VOLUME 2 OF 2 - ZONING

AAJ
217 WEST 10TH STREET
NEW YORK, NY

Z-003.00

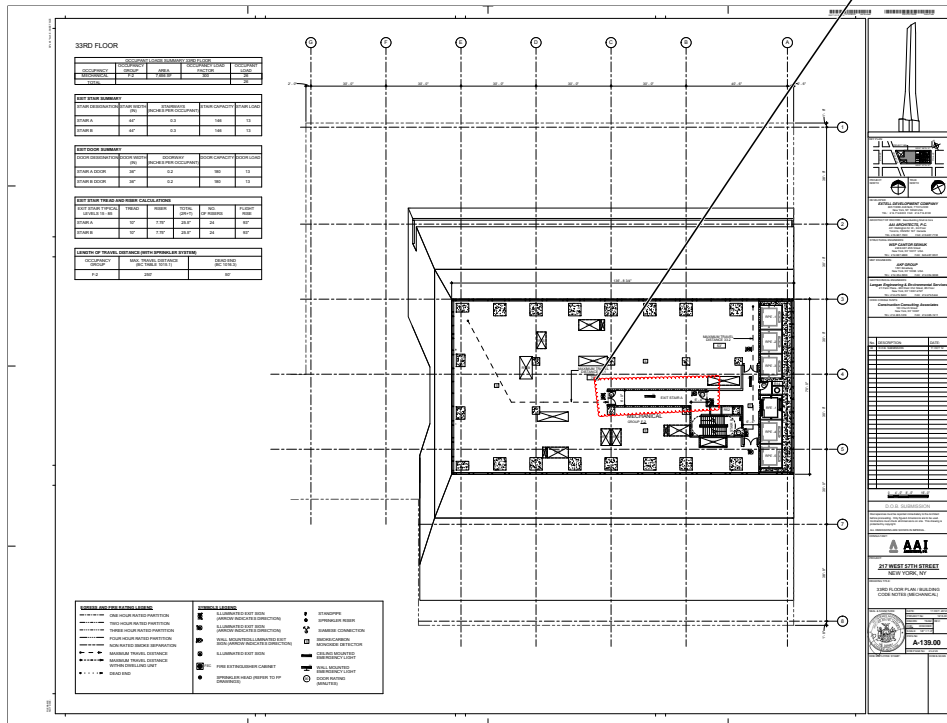
BC 1101.1, 1101.2, and
ICC/ANSI A117.1-2003 Verify compliance with accessibility as per BC 1101
Primary access- 1105
Doors & maneuvering clearances- 1107.2.1
Residential bathrooms - 1107 / Appendix P
Residential kitchens - 1107.
Show all grab-bars including vertical as per P102.8.3.1,
Walk-in closets
Access to W/D within units
TYP: all R-2 floors

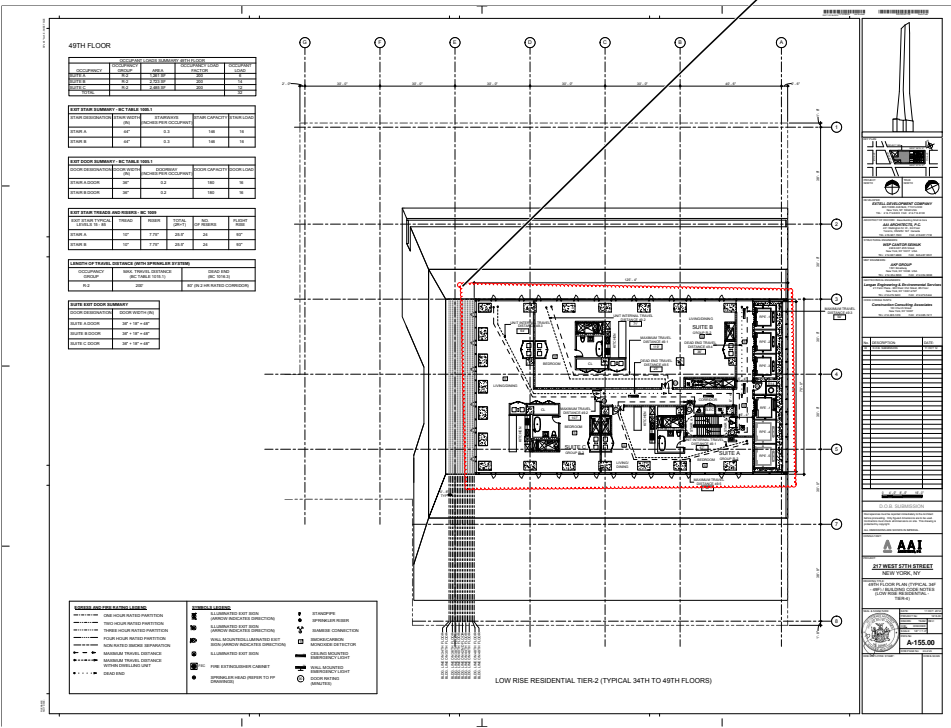
Provide fire protection of openings in exterior walls (BC 704.8, BC 705.8, BC 715.4).

note required on elevation dwg. to indicate
1 hr rated wall.

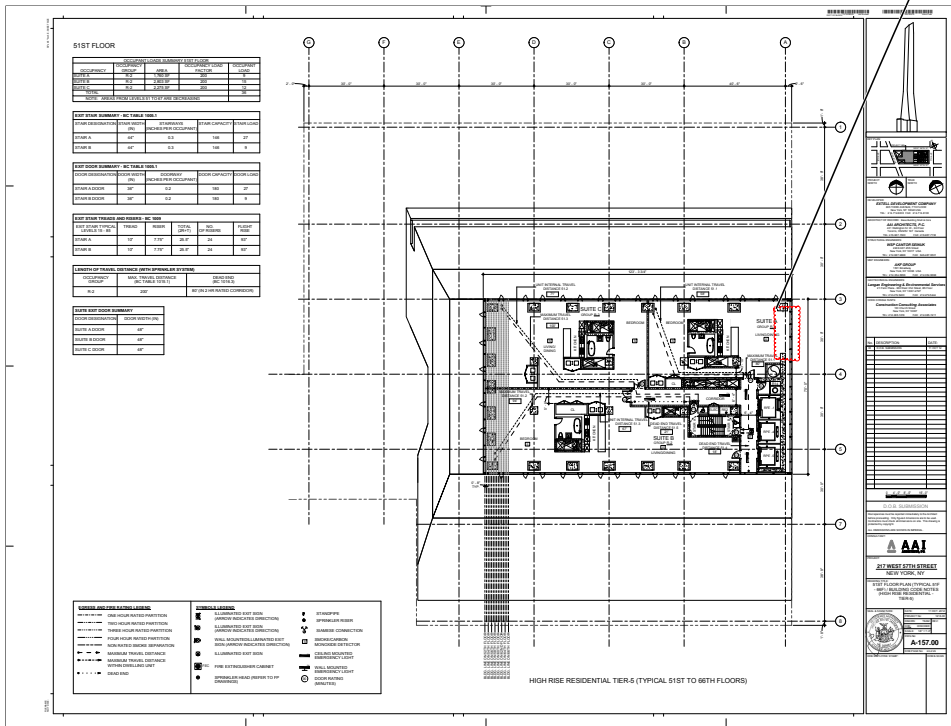
Propose mechanical room is not permitted to open into stair enclosure as per BC1019.1.2

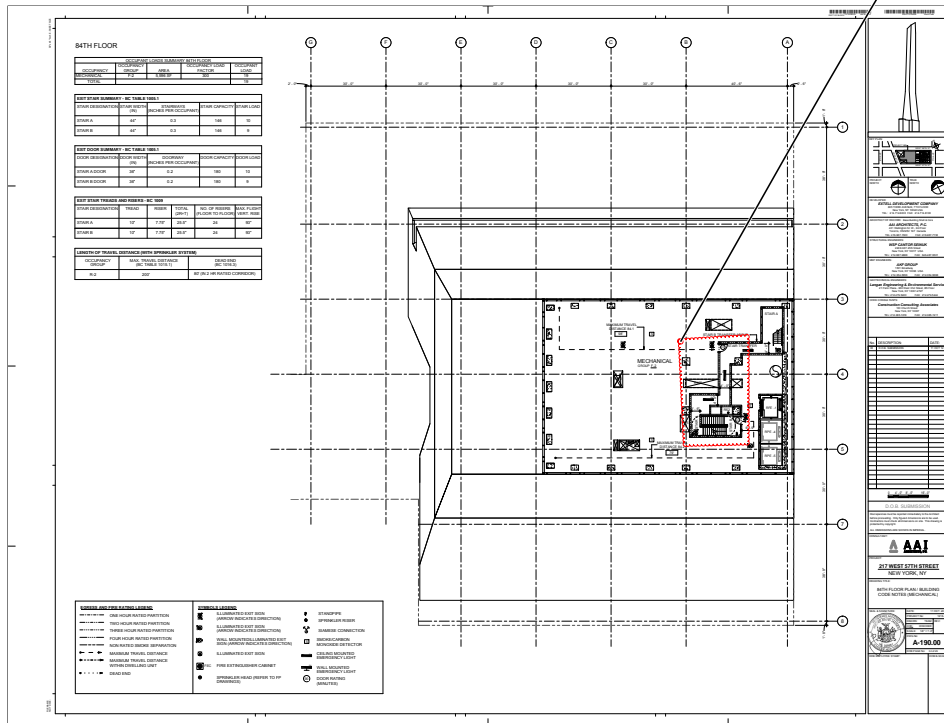
BC 403.11.1 Emergency power systems for assembly occupancy

1. Exit signs and means of egress illumination required by chapter 10.2.
3. emergency voice communications systems; and
4. Electrically powered fire pumps, unless electrical power to the motor is taken ahead of the main from the street side of the service switch.

Author: dtitus Subject: Polygon Date: 1/2/2013 11:59:00 AM
All interior stairs must lead to the roof as per BC 1009.12

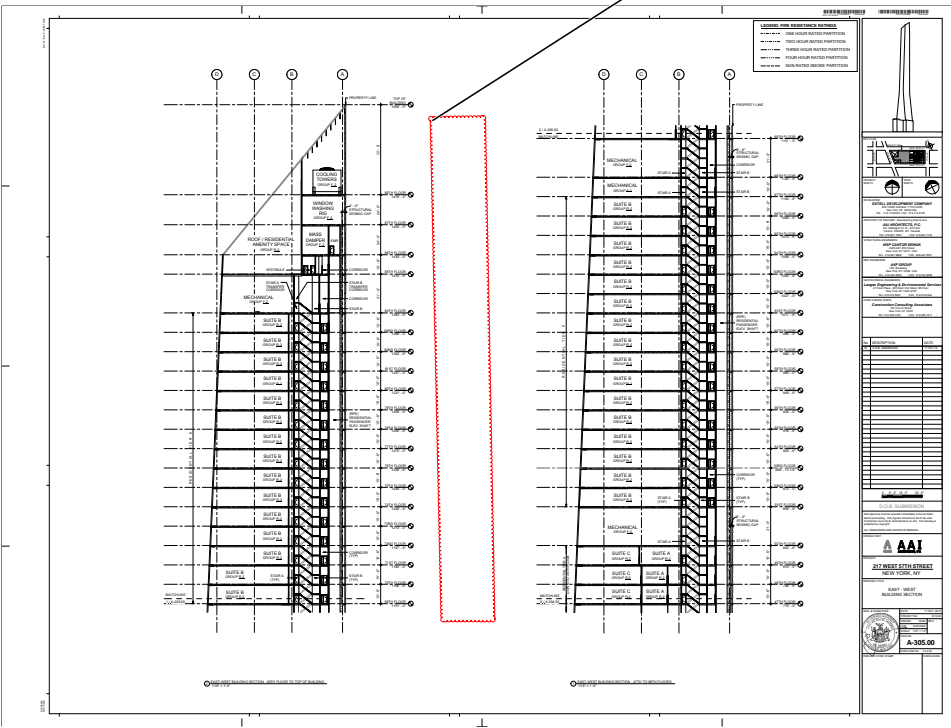
~~Provide all schedules windows, doors~~ (indicate FPSC on all fire rated doors) etc.

Provide structural peer review report as per BC 1627.

Provide building elements, exterior walls of non-combustible construction with fire-resistance ratings for Type I-B construction (BC 602.1, BC 602.2).

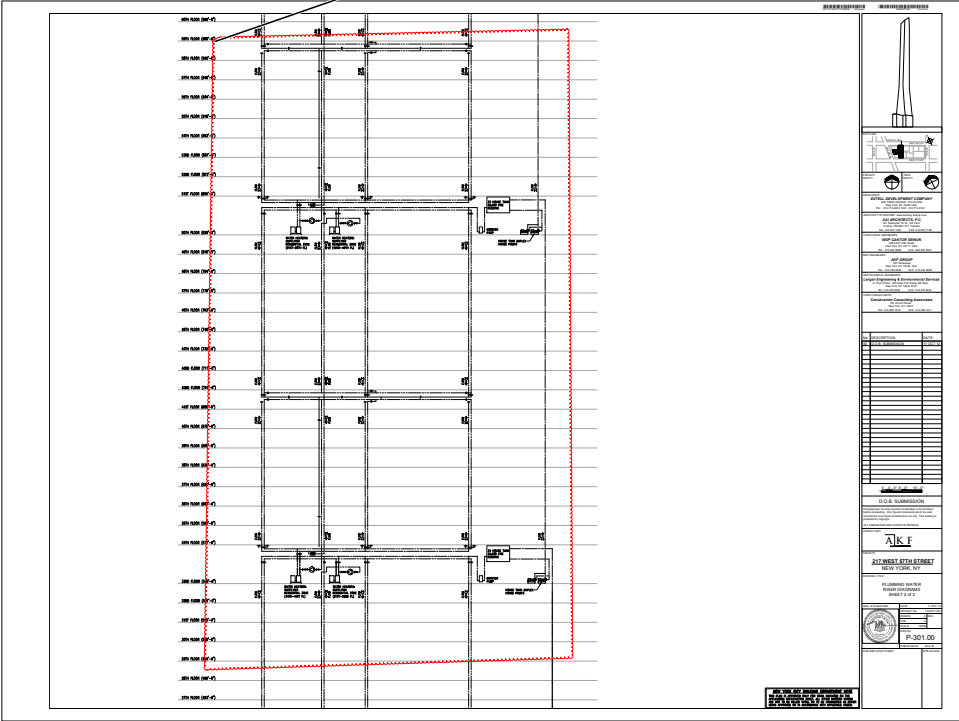
Author: dtitus Subject: Polygon Date: 1/8/2013 9:12:55 AM
Please provide a complete water and gas riser diagram.

Provide net area of space and number of persons to be accommodated based on (15) sq. ft./person as per table 1004.1.2 BC

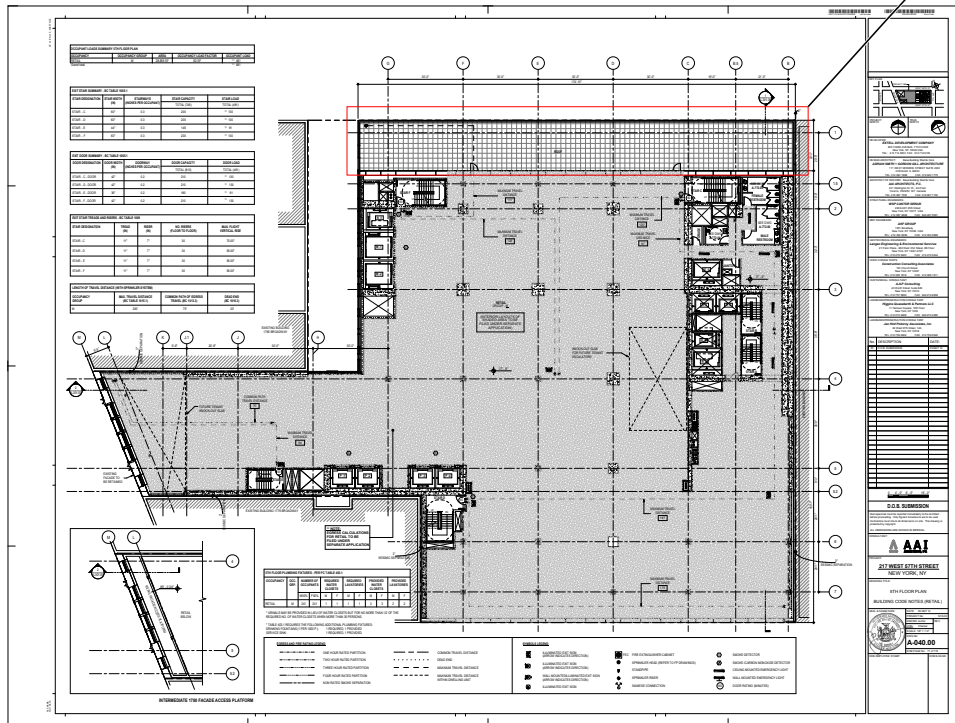
Provide net area of space and number of persons to be accommodated based on (15) sq. ft./person as per table 1004.1.2 BC.

Provide exit lighting and directional signs (lighting) & (egress) as per ~~BC 1006~~, BC 1011, BC 1026 (both EG and Construction plans)

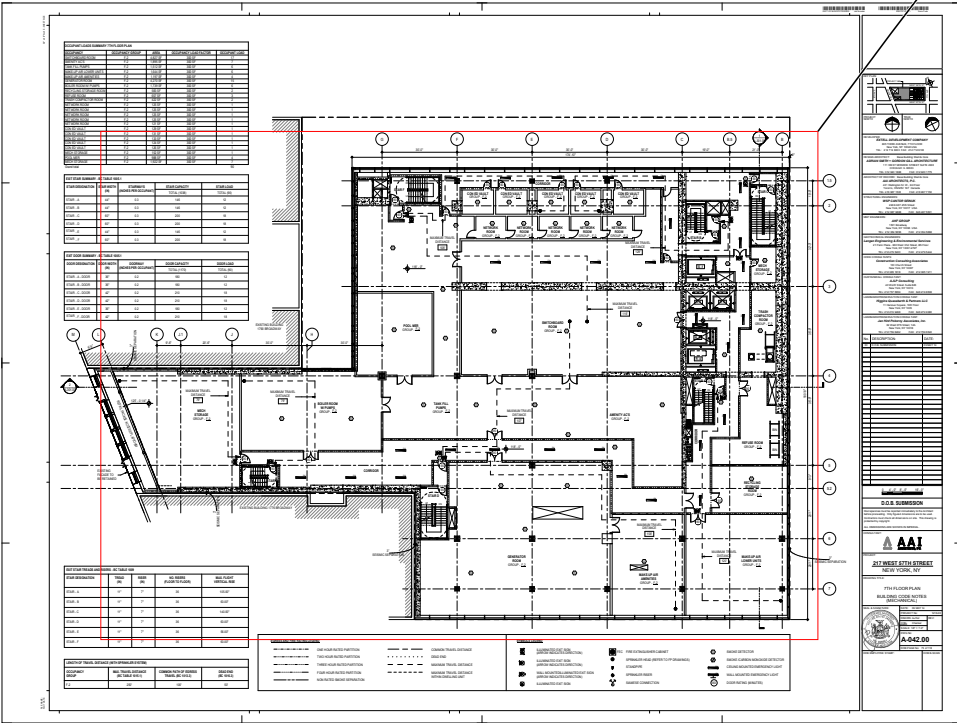
Author: dtitus Subject: Rectangle Date: 10/7/2014 8:25:25 AM
TABLE 403.1 Provide table for plumbing fixtures to comply with table. 403.1. Provide calculations within each space, 11-18-14

Provide the required number of exits per space, per maximum occupant load as per Table 1014.1. 01-12-15

Provide the required number of exits per space, per maximum occupant load as per Table 1014.1. 11-18-14

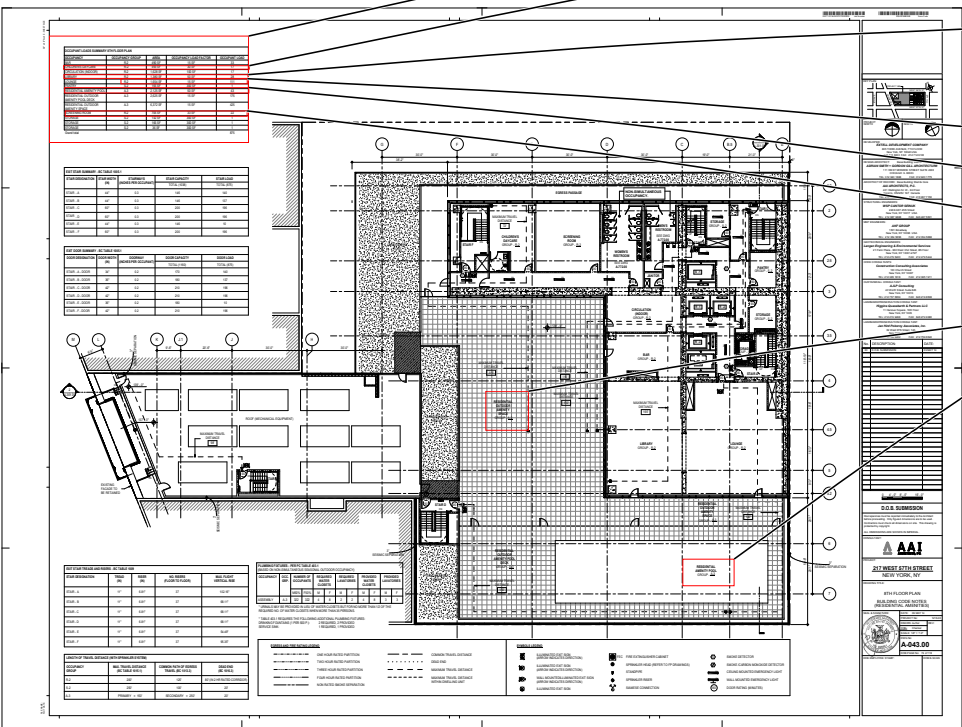
Provide the required number of exits per space, per maximum occupant load as per Table 1014.1. 01-12-15

Author: dtitus Subject: Rectangle Date: 10/7/2014 8:28:30 AM
Provide exit signs as per BC 1006, BC 1011, BC 1026 (both EG and Construction plans) 11-18-14

Author: dtitus Subject: Rectangle Date: 10/7/2014 8:45:47 AM
Propose swimming pool not located within a building does not meet the requirements of ZR 12-10 accessory use (5), (ii).

kitchen to be verified????

Author: dtitus Subject: Rectangle Date: 10/7/2014 9:10:59 AM
one space A- occupancy.

Author: dtitus Subject: Rectangle Date: 10/7/2014 9:12:42 AM
Showers not permitted if acc. to R occupancy.

11-18-14 pool below roof line.
see A021 for compliance

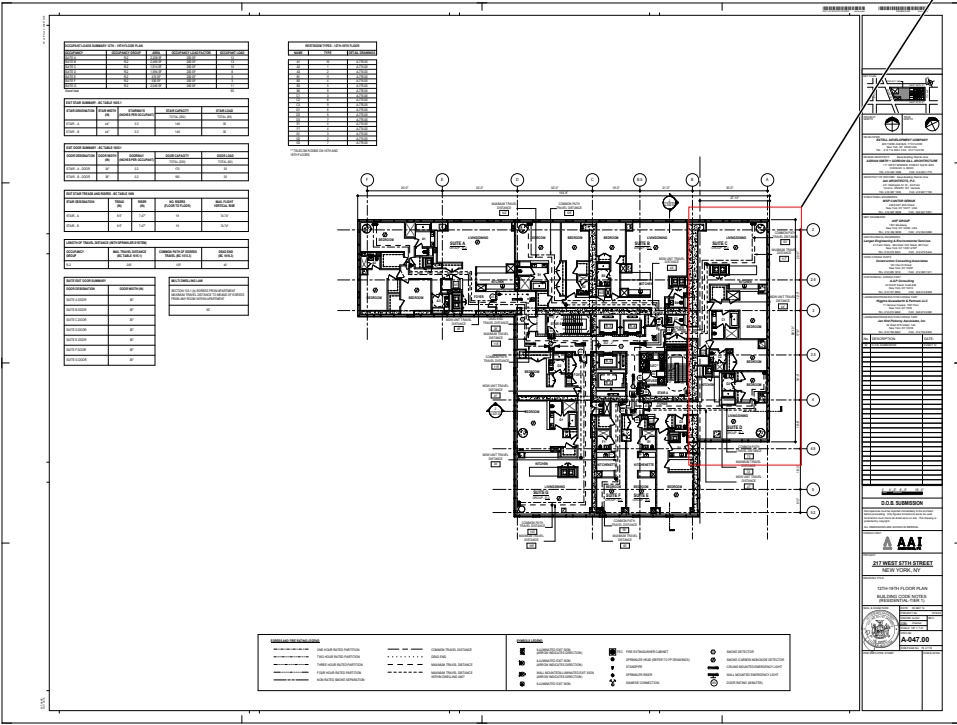
Author: ditus Subject: Rectangle Date: 10/7/2014 9:35:51 AM
8C 1101.1, 1101.2, and
ICC/ANSI A117.1-2003Verify compliance with accessibility as per 8C 1101.1
1.Doors & maneuvering clearances-1107.2.1
2.Residential bathrooms – 1107/ Appendix P
3.Residential kitchens – 1107.
4.Showers & grab bars including vertical as per P 102.6.3.1.
5.Walk-in closets
6.Access to W/D within units (Where washing machines or clothes dryers
comply with Section 611 (Washing Machines and Clothes Dryers) of ICC
common-use areas as required in Section 1107.3 shall comply with Section

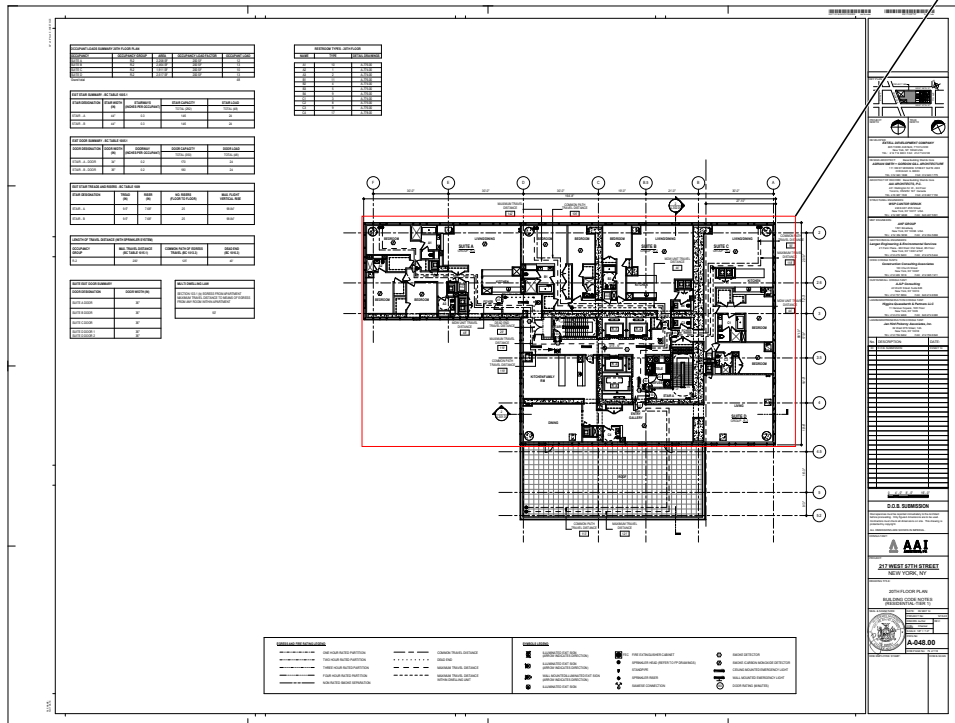
- BC 1101.1, 1101.2, and
ICC/ANSI A117.1-2003 Verify compliance with accessibility as per BC 1101
1.Doors & maneuvering clearances-1107.2.1
2.Residential bathrooms – 1107/ Appendix P
3.Residential kitchens – 1107.
4.Show all grab-bars including vertical as per P102.8.3.1,
5.Walk-in closets
6.Access to W/D within units (Where washing machines or clothes dryers are provided within the dwelling or sleeping unit, such equipment shall comply with Section 611 (Washing Machines and Clothes Dryers) of ICC A117.1 and shall be front loading. Laundry equipment in accessible common-use areas as required in Section 1107.3 shall comply with Section E105.3. (TYP ALL R-2 Floors)

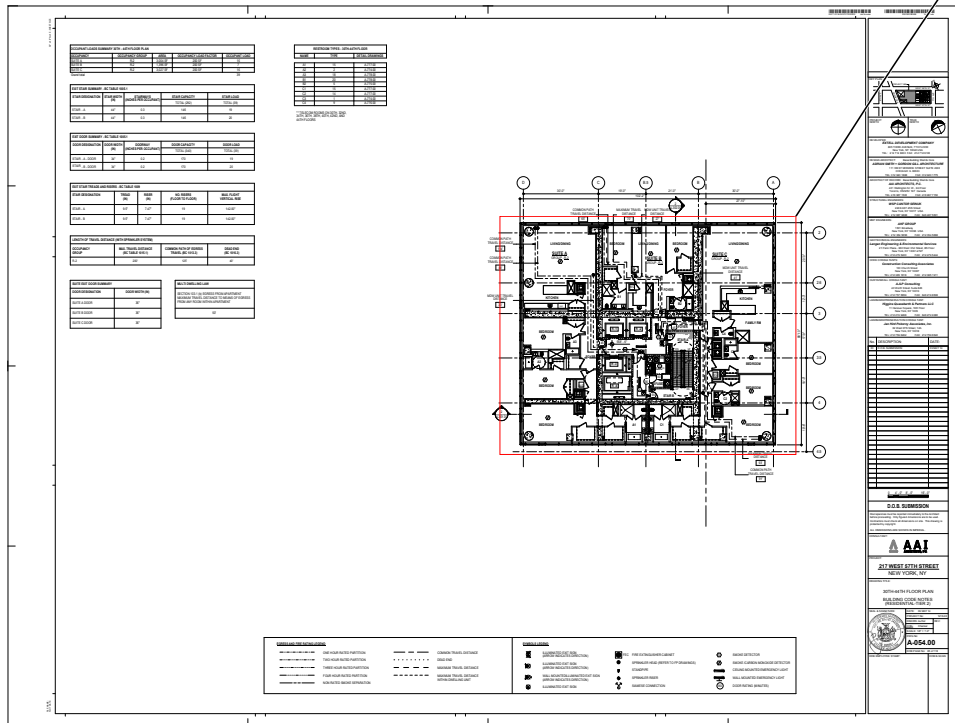
Author: dtitus Subject: Rectangle Date: 10/7/2014 9:24:08 AM
Sufficient proof must be provided for entire fa deducted. Provide layout of heavy equipment for each floor in consideration to qualify for deductions.
